ITS CORPORATION				REV	ECN	DATE	APV
THIS PRINT IS THE PROPERTY OF ITS CORP. IT SHALL NOT BE COPIED WITHOUT PERMISSION.				TITLE BLOCK DIAGRAM - UHF AMPLIFIER (1281-1100)			
MATERIAL				DWN	TMY	7/9/96	DWG. NO.
---				CHK	RE	7/10/96	1281-3100
FINISH				REL	RE	7/11/96	2
---				SCALE:--- SHEET 1 OF 1

ITS CORPORATION				REV	ECN	DATE	APV
REV	ECN	DATE	APV	THIS PRINT IS THE PROPERTY OF ITS CORP. IT SHALL NOT BE COPIED WITHOUT PERMISSION.			
				TITLE <i>SCH, UHF COUPLER ASSEMBLY (1227-1316)</i>			
REV	ECN	DATE	APV	MATERIAL			REV
				DWN <i>SJM</i> 2/16/94 CHK <i>DWB</i> 4-11-94 REL <i>DWB</i> 4-11-94			0
FINISH				DWG. NO.		SHEET 1 OF 1	
1227-3316				A		SCALE ---

ADC Telecommunications				A0		20028104		5/17/99		LRT			
								REV		ECO		DATE		APV			
APV		THIS PRINT IS THE PROPERTY OF ADC, IT SHALL NOT BE COPIED WITHOUT PERMISSION.				TITLE SCH, SINGLE STAGE AMPLIFIER ASSY., CLASS A, MID BAND (1265-1416)											
DATE		MATERIAL -----															
ECO		FINISH -----				DWN		GK		1/29/96		DWG. NO. 1265-3416				REV B0	
REV						REL		JAG		3/19/96		C		SCALE ---		SHEET 1 OF 1

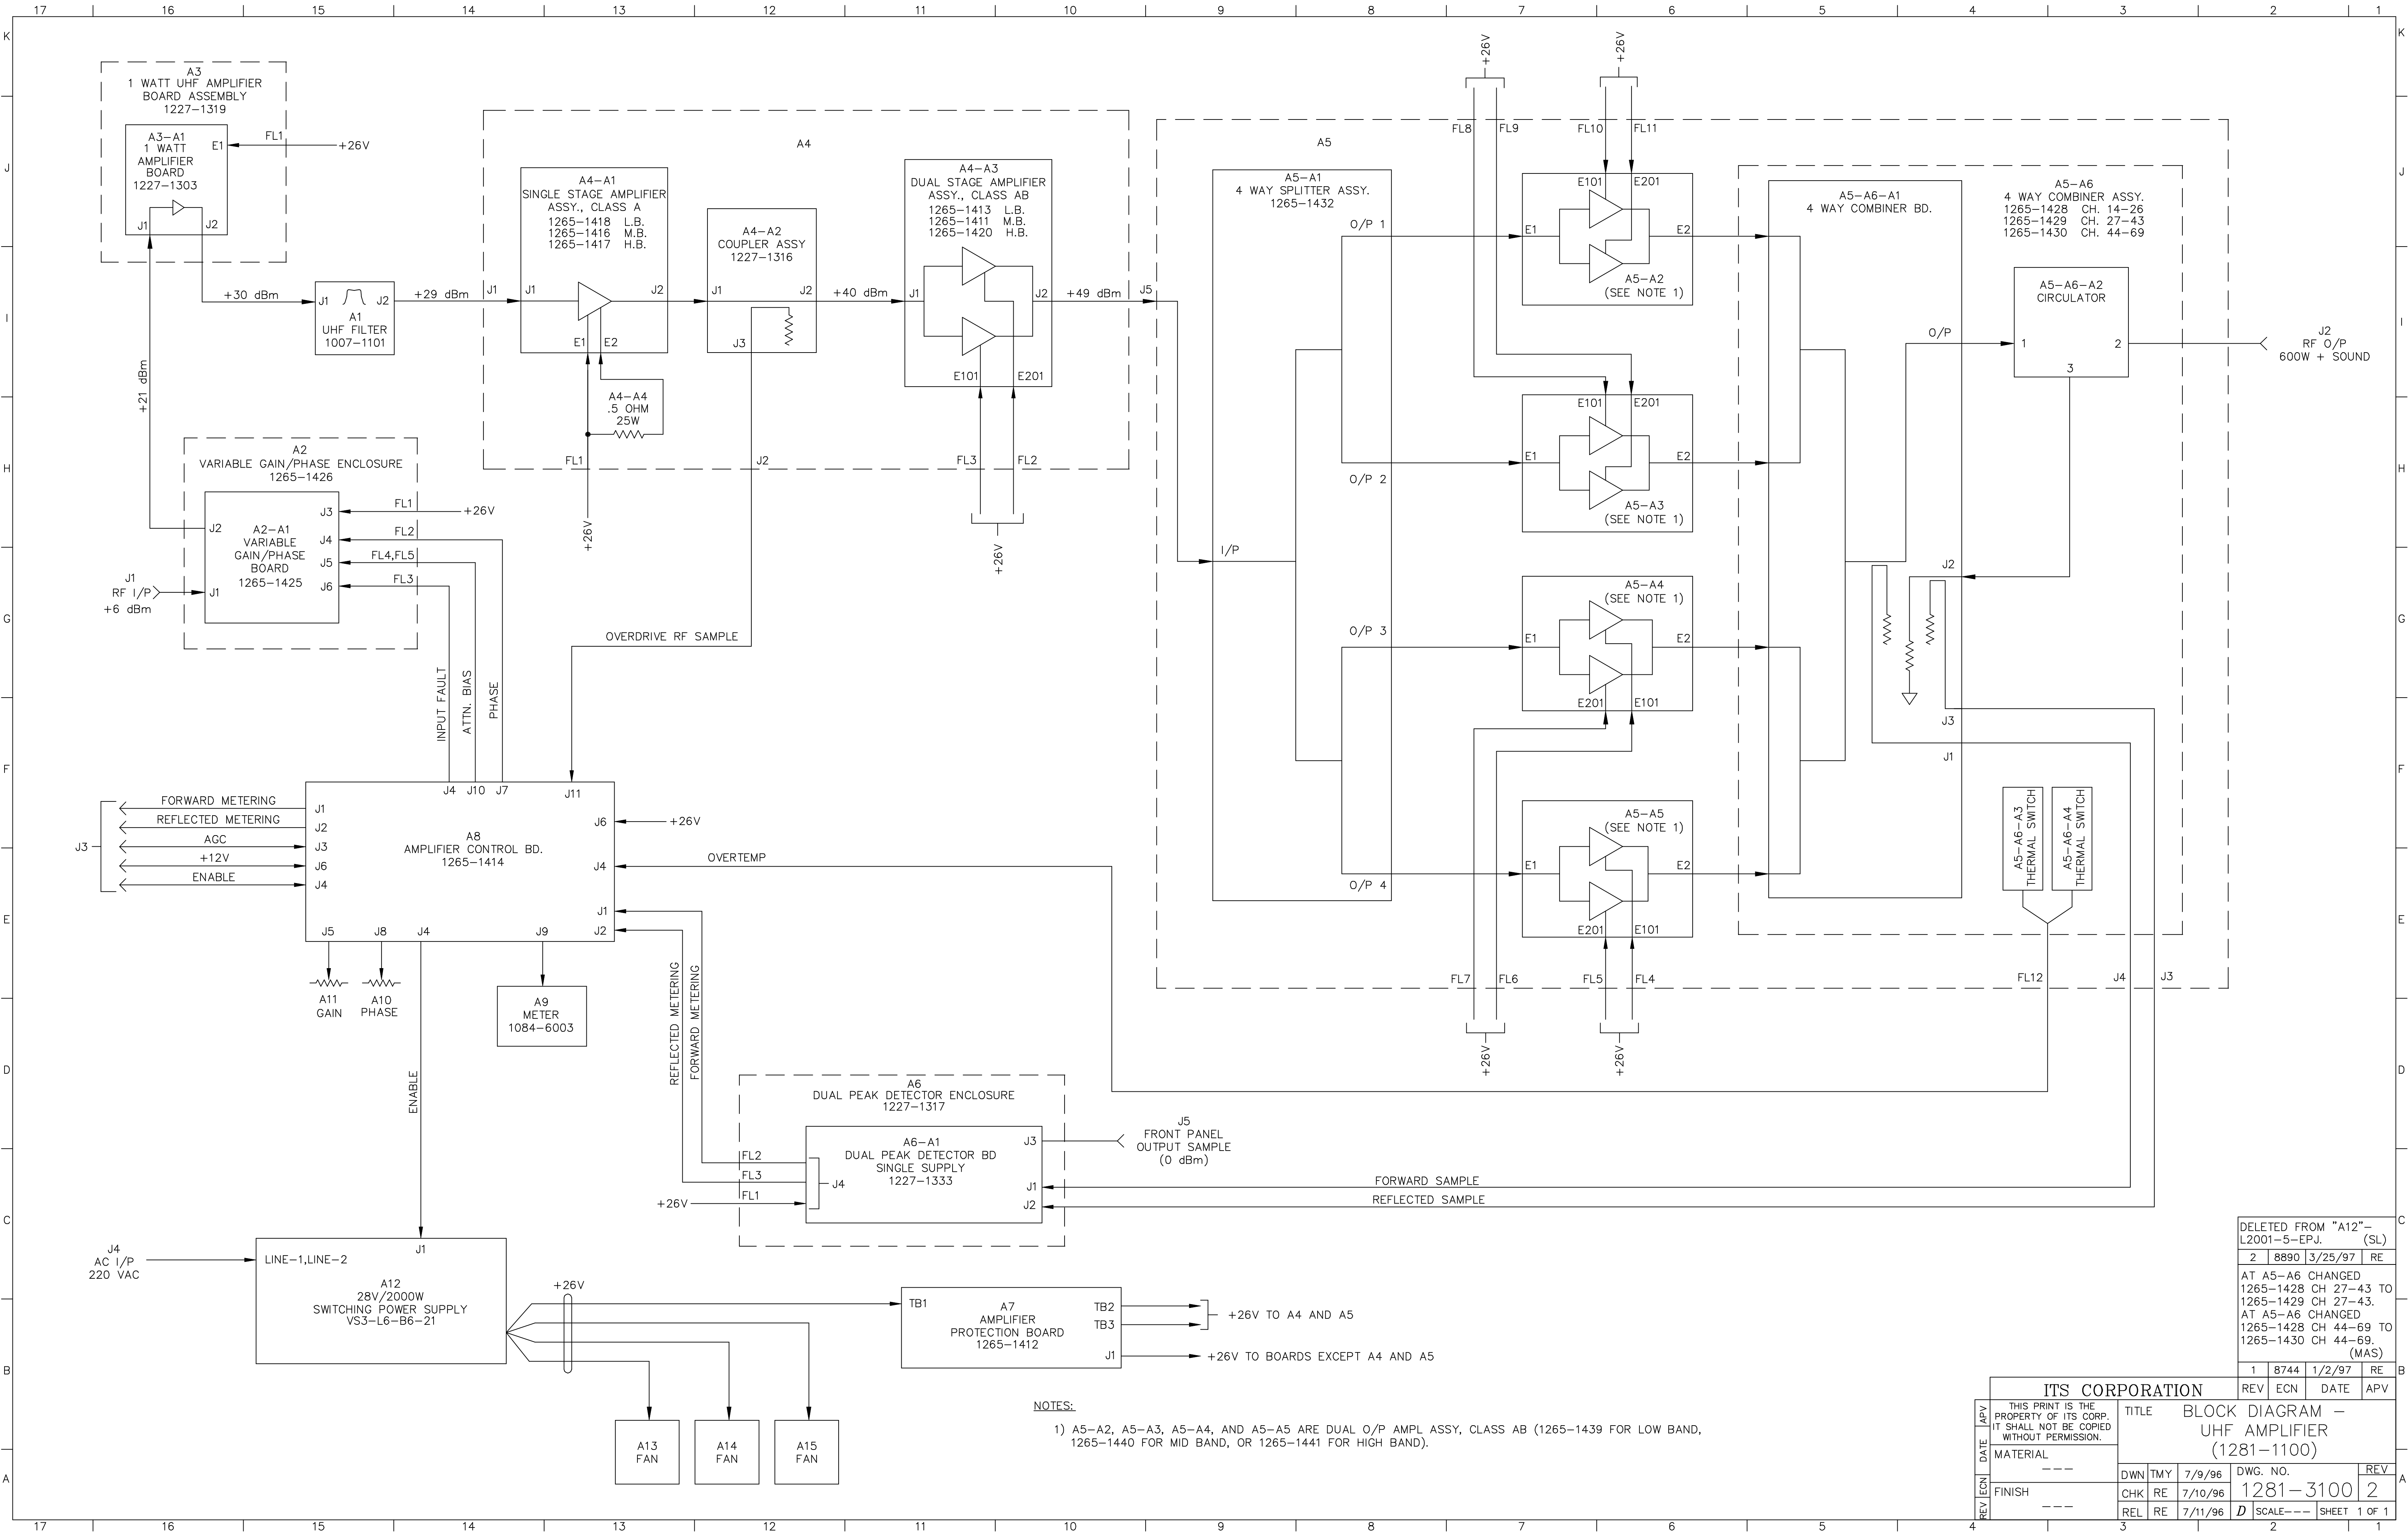
DELETED FROM "A12"-L2001-5-EPJ. (SL)			
2	8890	3/25/97	RE
AT A5-A6 CHANGED 1265-1428 CH 27-43 TO 1265-1429 CH 27-43. AT A5-A6 CHANGED 1265-1428 CH 44-69 TO 1265-1430 CH 44-69. (MAS)			
1	8744	1/2/97	RE

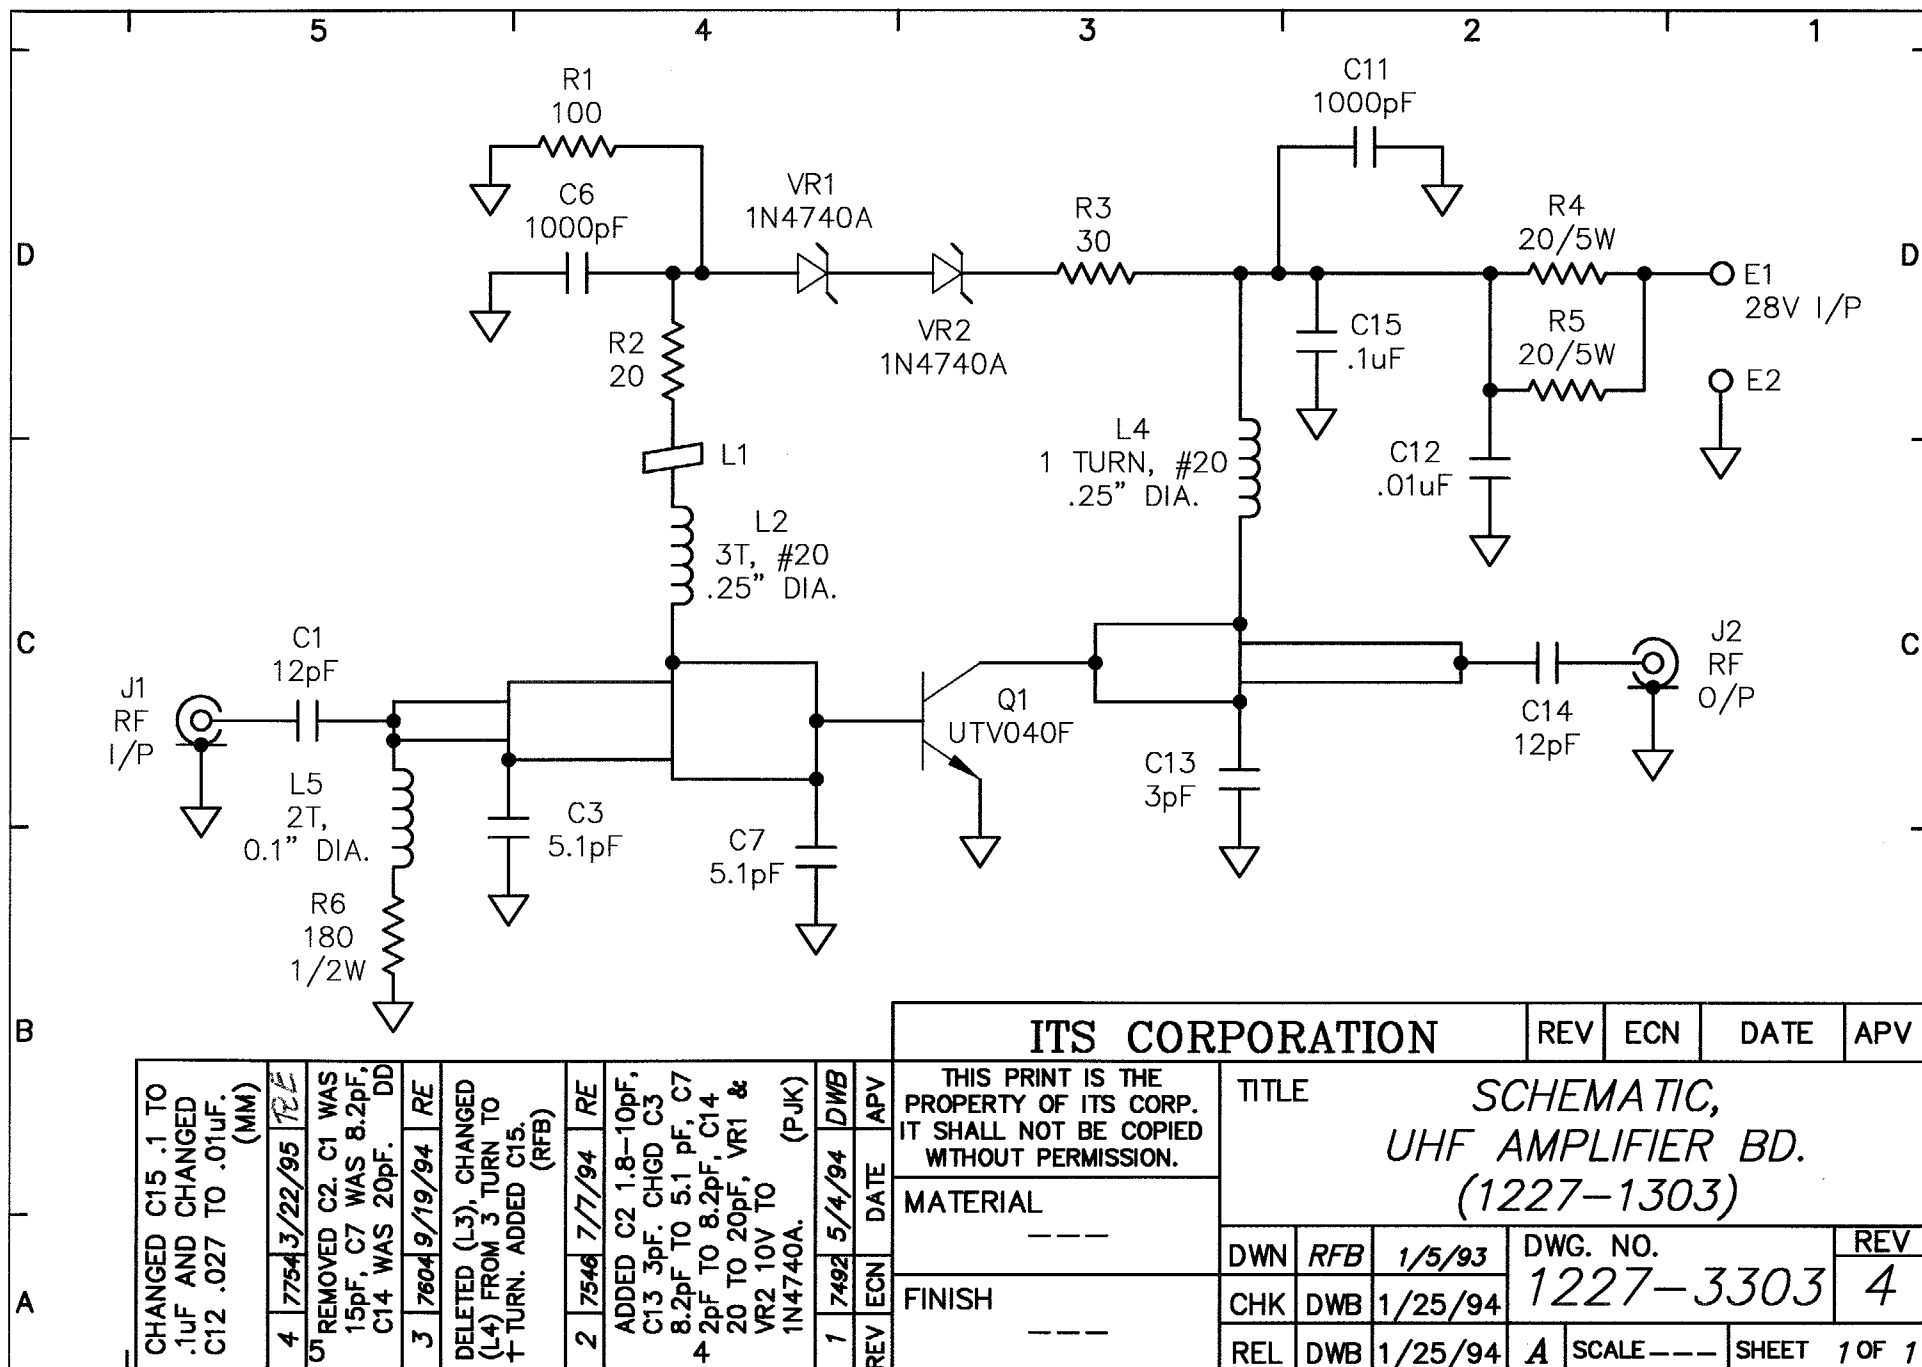
CHANGED C15 .1 TO .1uF AND CHANGED C12 .027 TO .01uF. (MM)		
4	77543/22/95	RE
C1 REMOVED C2. C1 WAS 15pF, C7 WAS 8.2pF, C14 WAS 20pF. DD		
3	78049/19/94	RE
DELETED (L3), CHANGED (L4) FROM 3 TURN TO 1 TURN. ADDED C15. (RFB)		
2	75467/7/94	RE
ADDED C2 1.8-10pF, C13 3pF. CHGD C3 8.2pF TO 5.1 pF, C7 2pF TO 8.2pF, C14 20 TO 20pF, VR1 & VR2 10V TO 1N4740A. (PJK)		
1	74925/4/94	DWB
REV	ECN	DATE
APV	APV	APV

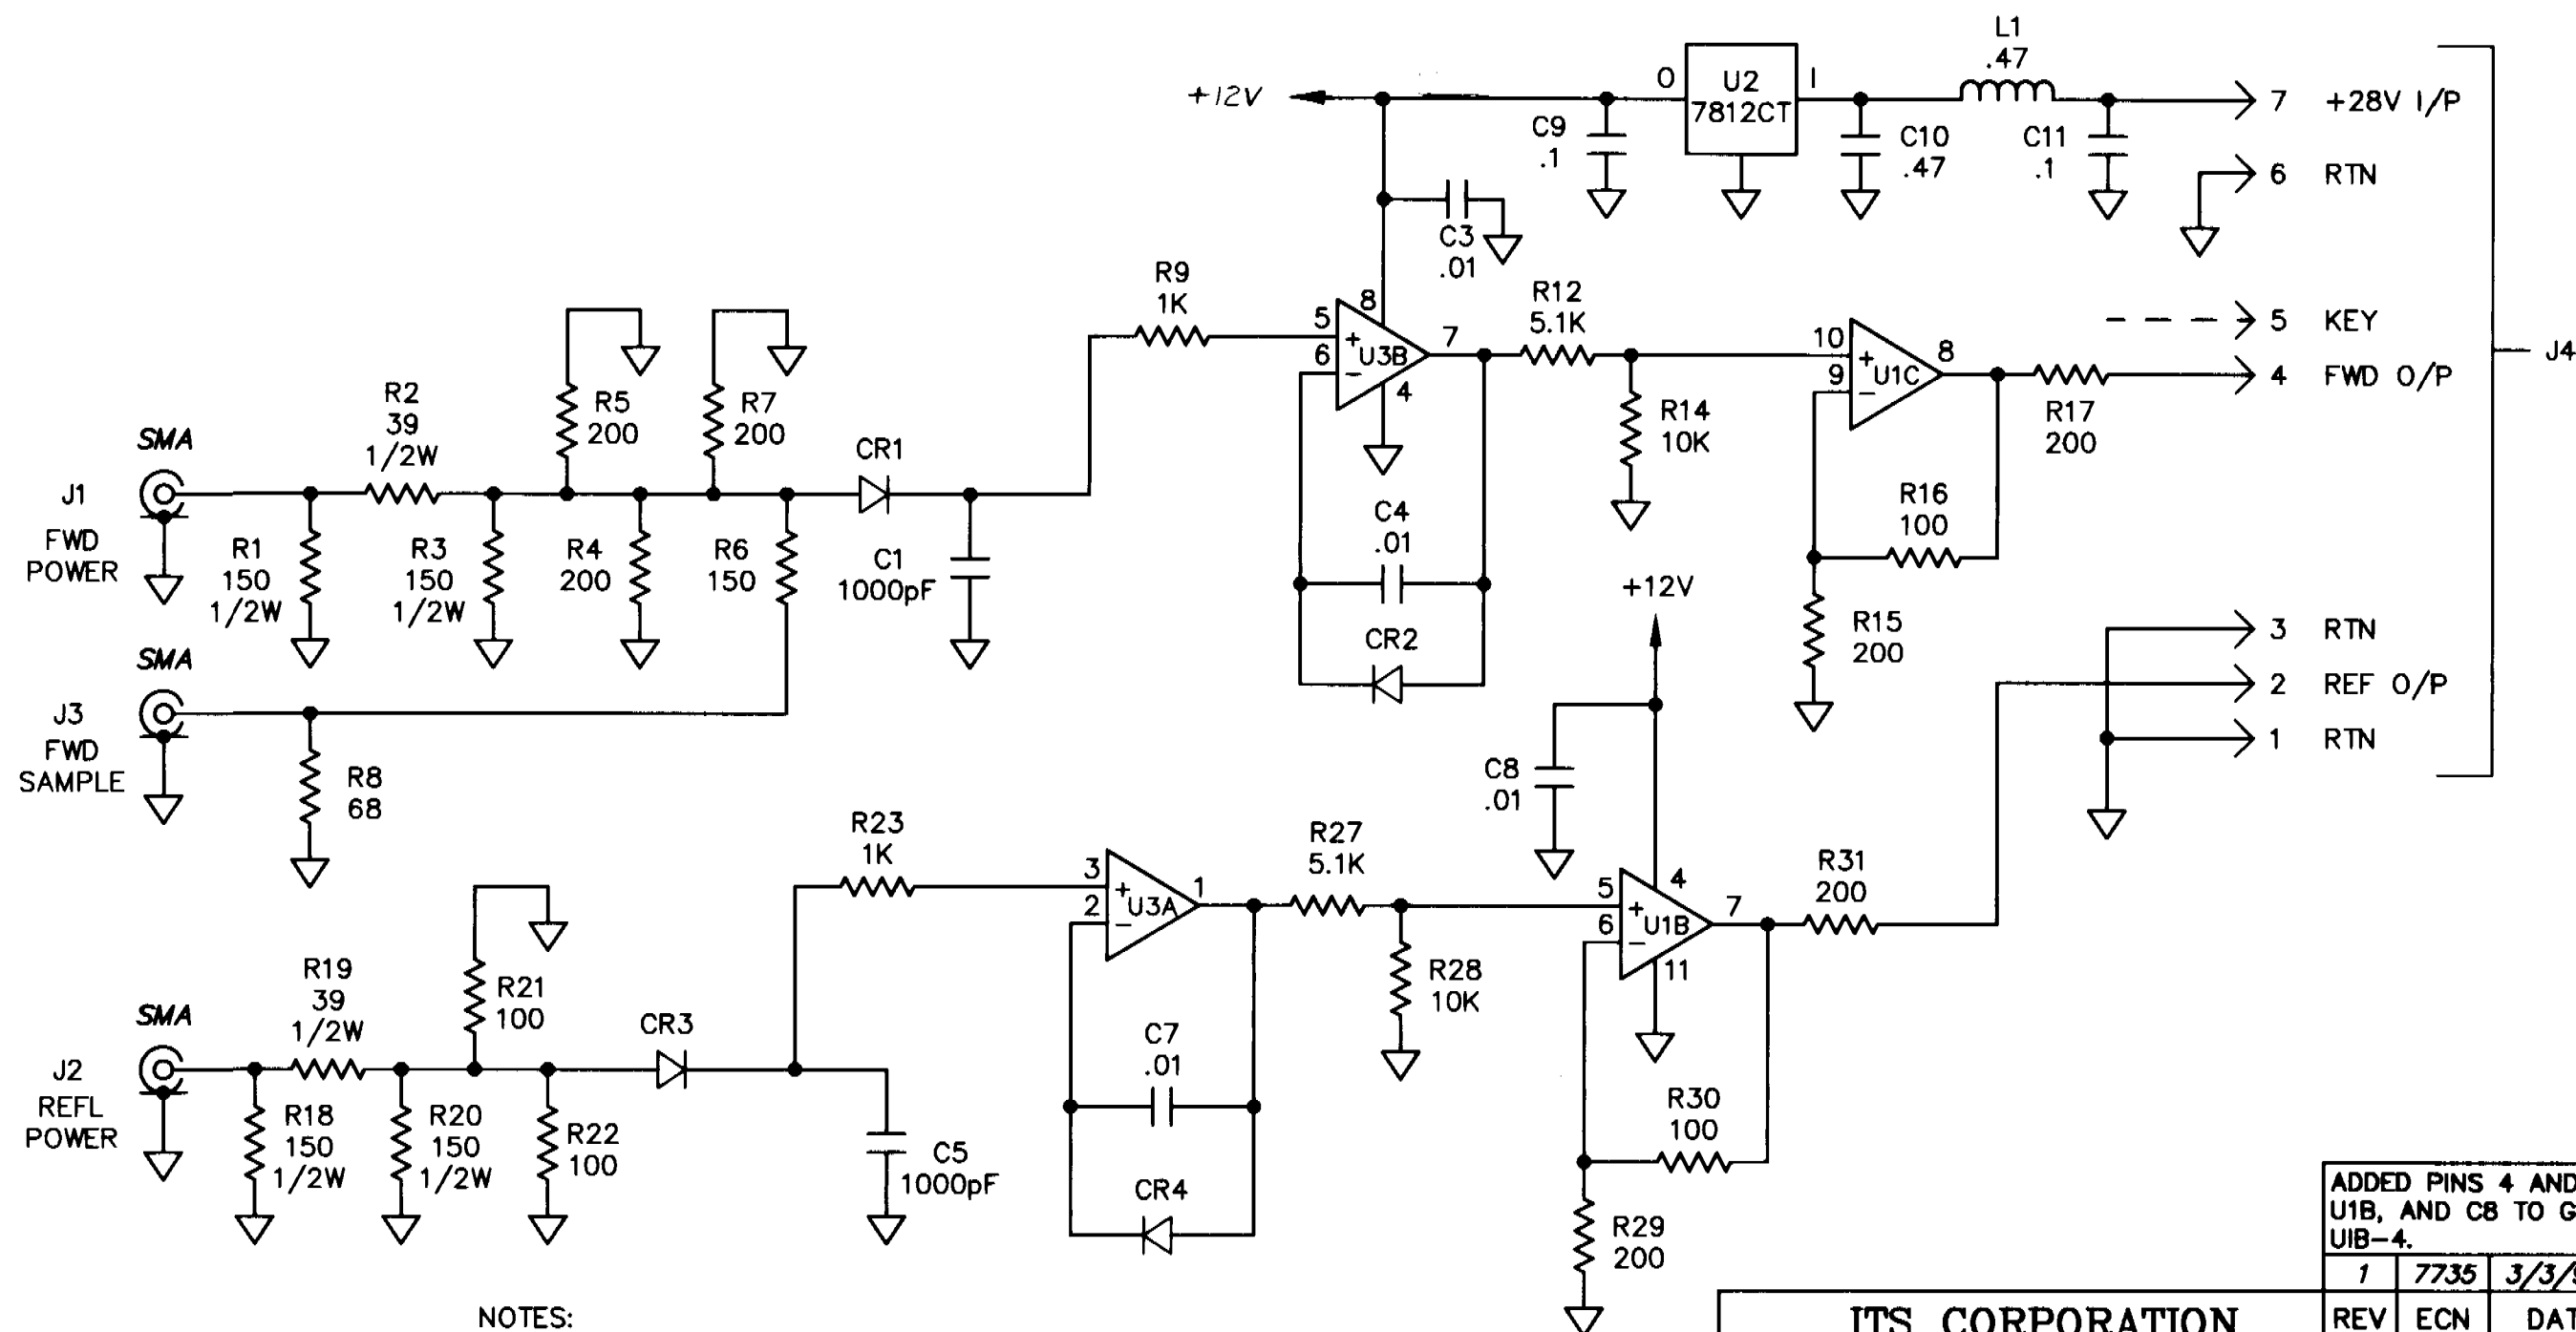
ADDED PINS 4 AND 11 TO U1B, AND C8 TO GND FROM UIB-4.				SJM		
				1	7735	3/3/95	RE			
				REV	ECN	DATE	APV			
ITS CORPORATION										
THIS PRINT IS THE PROPERTY OF ITS CORP. IT SHALL NOT BE COPIED WITHOUT PERMISSION.				TITLE SCHEMATIC, DUAL PEAK DET BD., SINGLE SUPPLY (1227-1333)						
MATERIAL -----				DWN		PJK	8/31/94	DWG. NO.		REV
FINISH -----				CHK		JAG	12/19/94	1227-3333		1
				REL		JAG	12/19/94	B	SCALE ----	SHEET 1 OF 1
